**Lee County Board Of County Commissioners
Agenda Item Summary**

Blue Sheet No. 20050444

LEE COUNTY CONSTRUCTION CONTRACT
CHANGE ORDER

LEE COUNTY PROPOSAL REQUEST

**PR 5.1
A105**

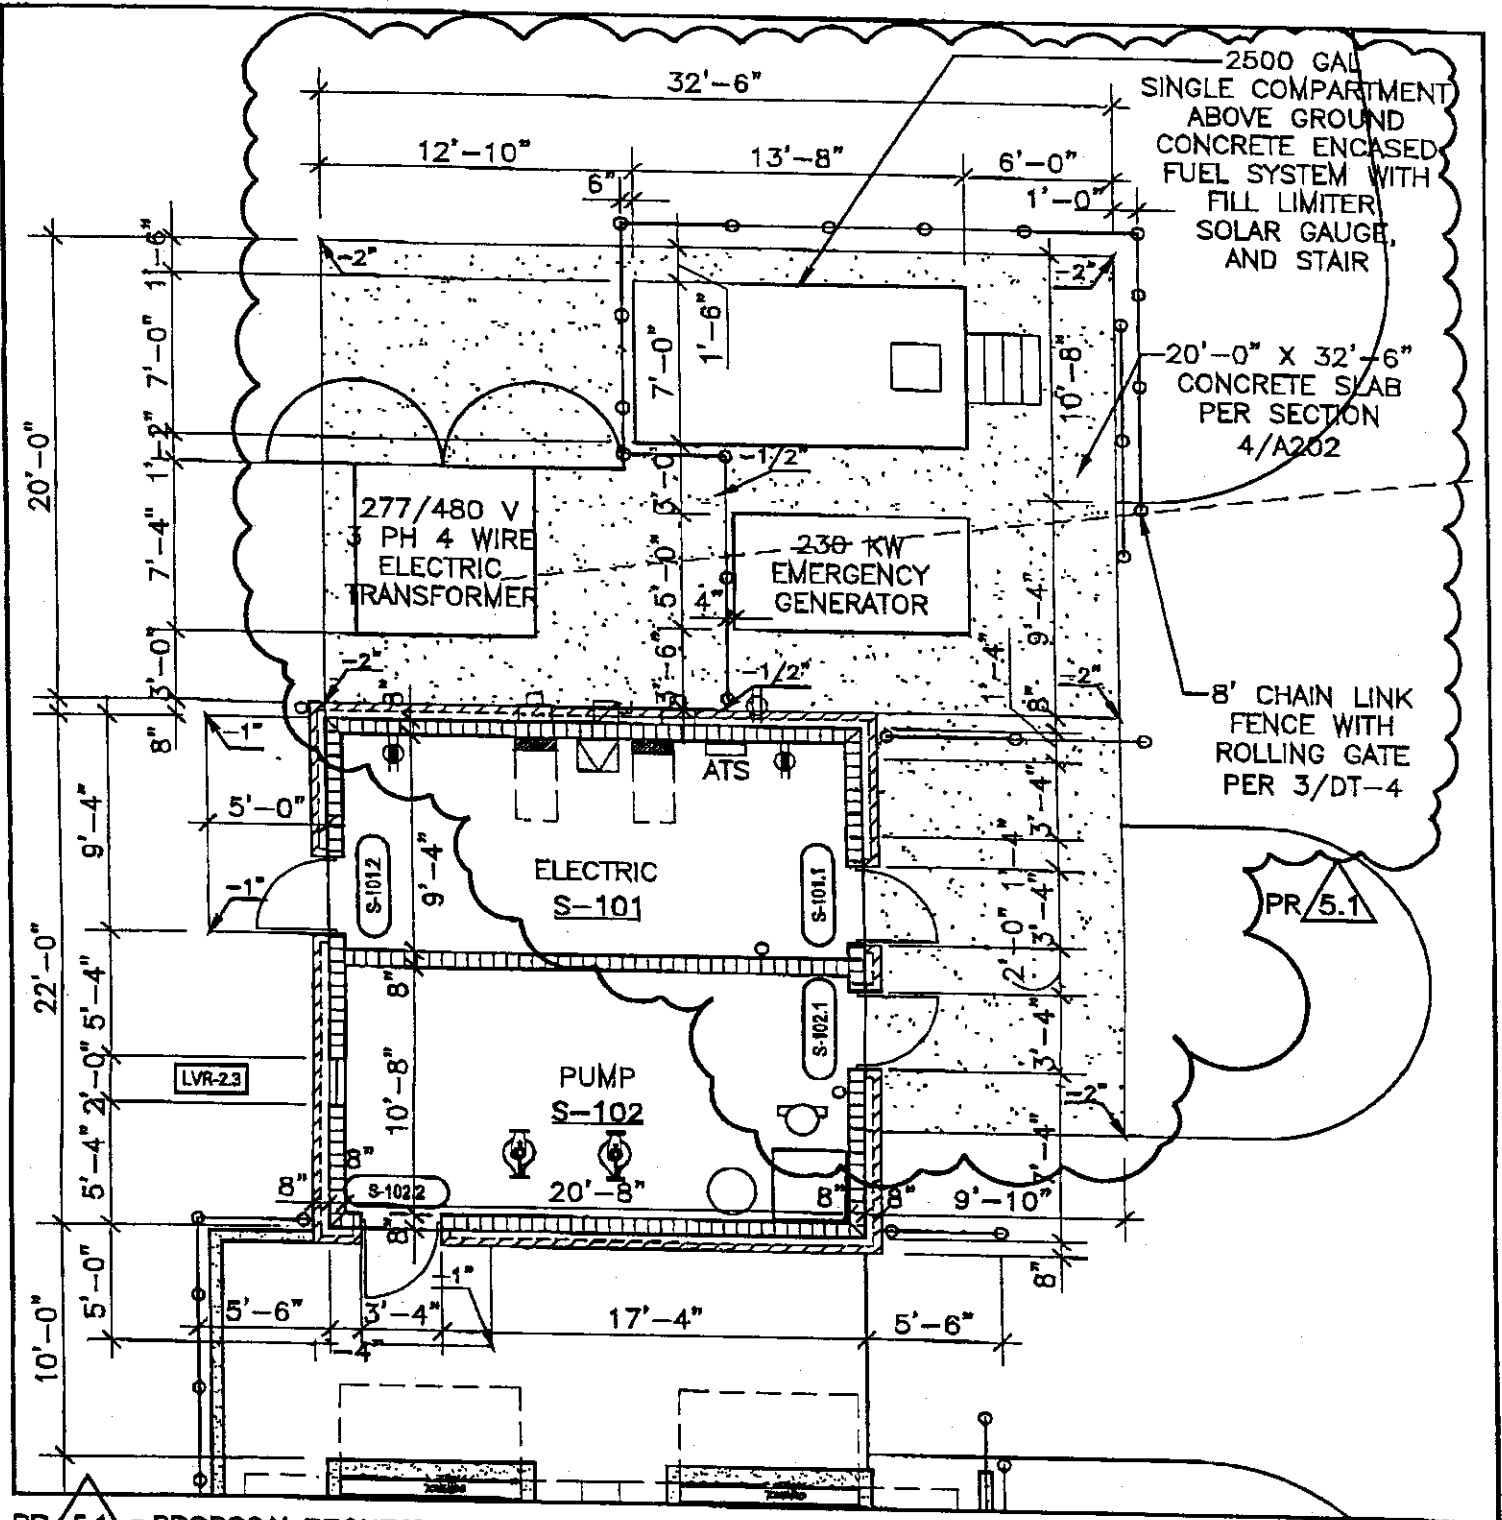
PROVIDE 230 KW EMERGENCY GENERATOR AND 2500 GAL SINGLE COMPARTMENT, ABOVE GROUND, CONCRETE ENCASED FUEL SYSTEM WITH FILL LIMITER, SOLAR GAUGE, AND STAIR ON 20'-0" X 32'-6" CONCRETE SLAB PER SECTION 4/A202 WITH AUTOMATIC TRANSFER SWITCH (ATS) IN ELECTRIC ROOM S-101 AND GENERATOR ANNUNCIATOR PANEL IN ENTRY LOBBY A-101 NEAR FIRE ALARM ANNUNCIATOR PANEL WITH 1" CONDUIT FROM GENERATOR TO PANEL

PR 5.1
4/A202

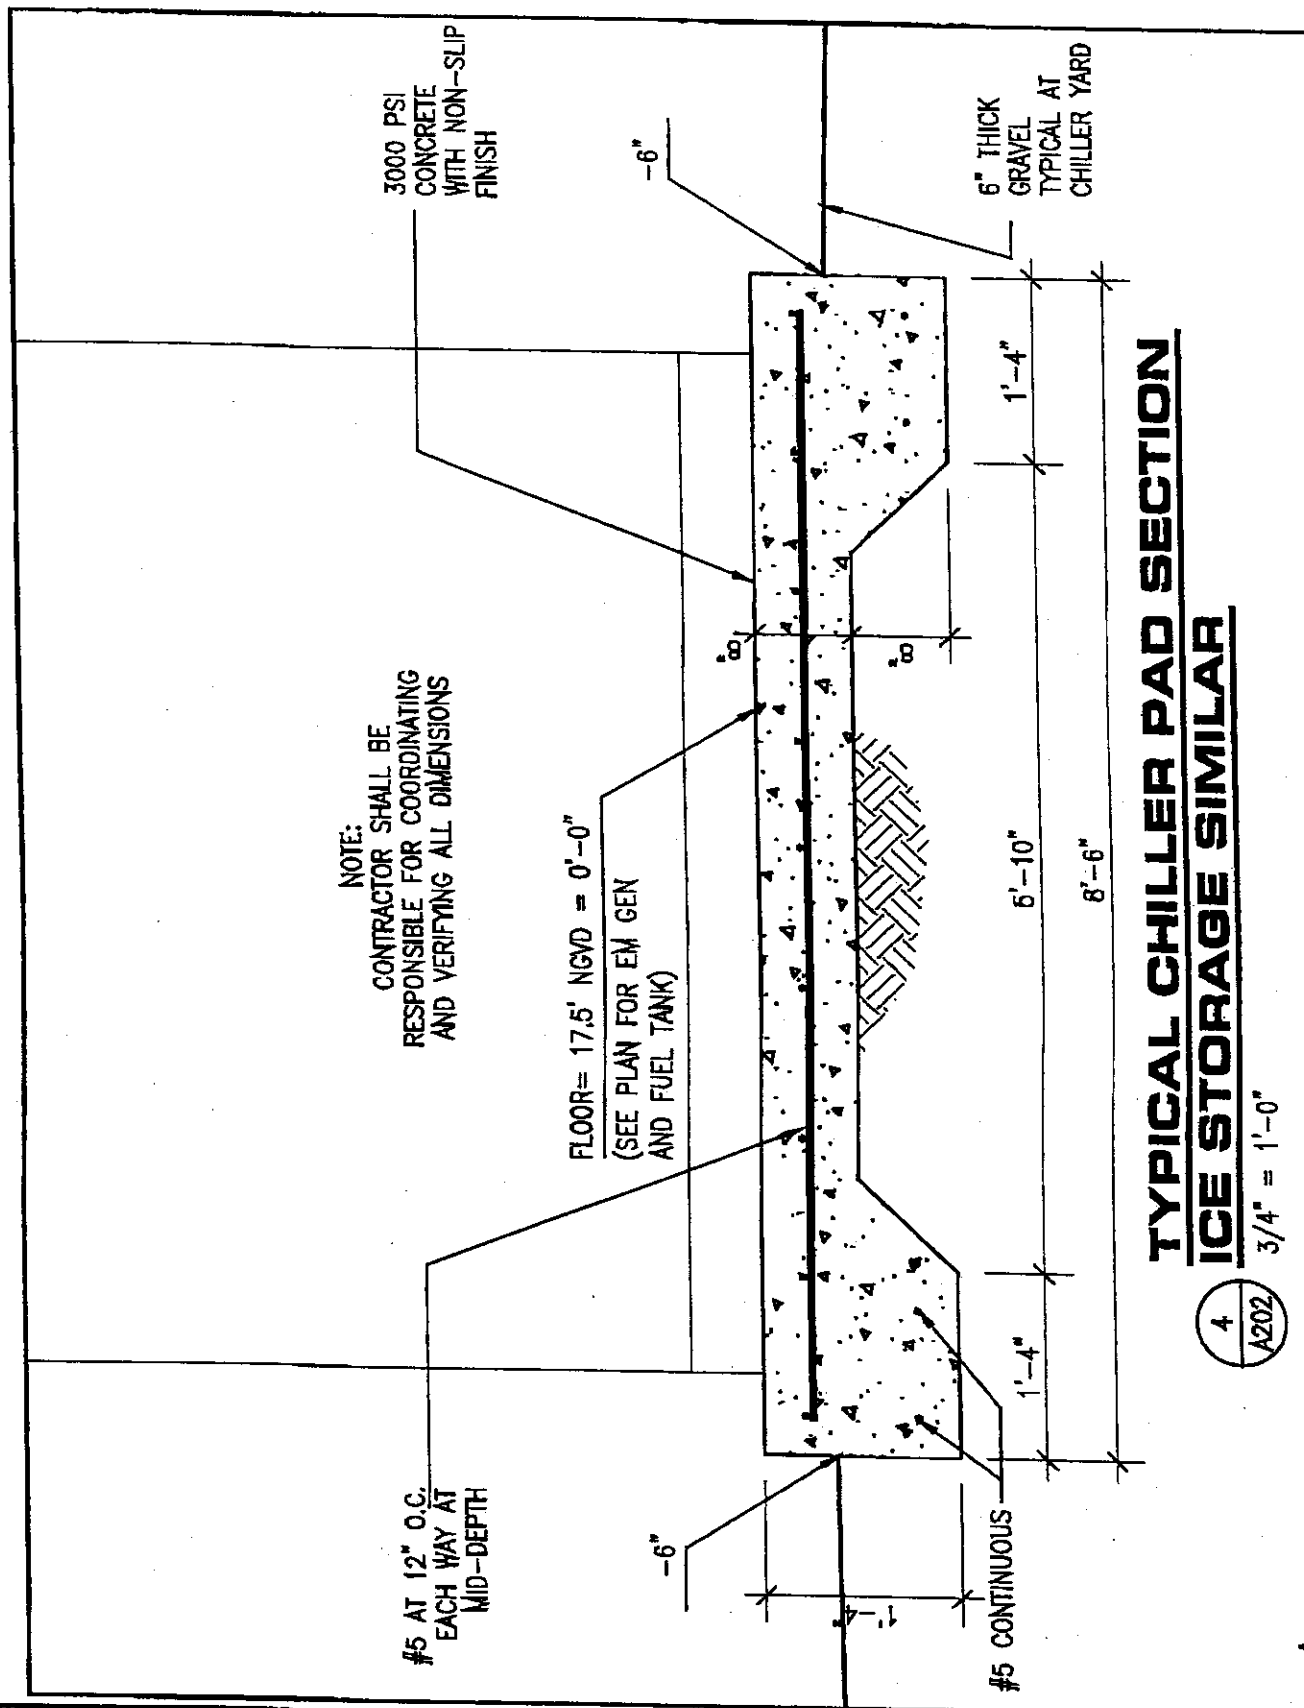
PR/5.1 = PROPOSAL REQUEST 5.1
 PROVIDE 20'-0" X 32'-6" CONCRETE SLAB PER SECTION 4/A202
 REFER TO SHEET PR 5.1 A105 FOR EMERGENCY GENERATOR AND FUEL SYSTEM
